Vermont Yankee Nuclear Power Station

Proposed Technical Specification Change No. 218

Enhancements to Support Implementation of Increased Core Flow

Marked-up Version of the Current Technical Specifications and Bases

APRM FLOW RELERENCE SCRAM AND APRM ROD BLOCK SETTINGS

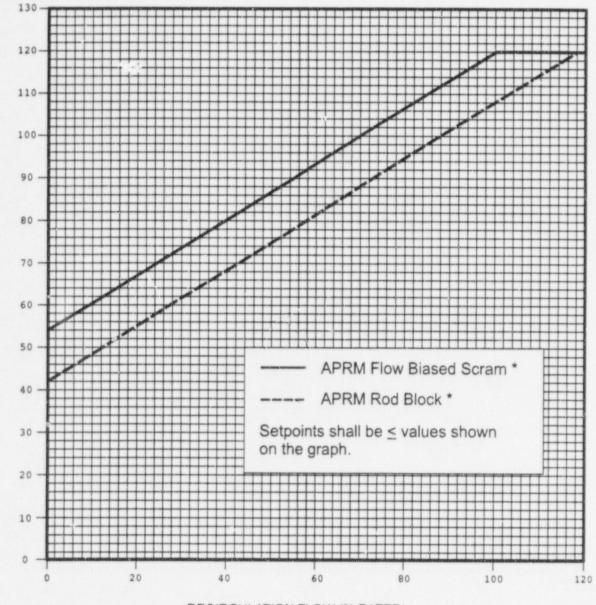
For single loop operation, the APRM Scram and Rod Block settings are adjusted according to Technical Specifications 2.1.A.1.a and 2.1.B.1
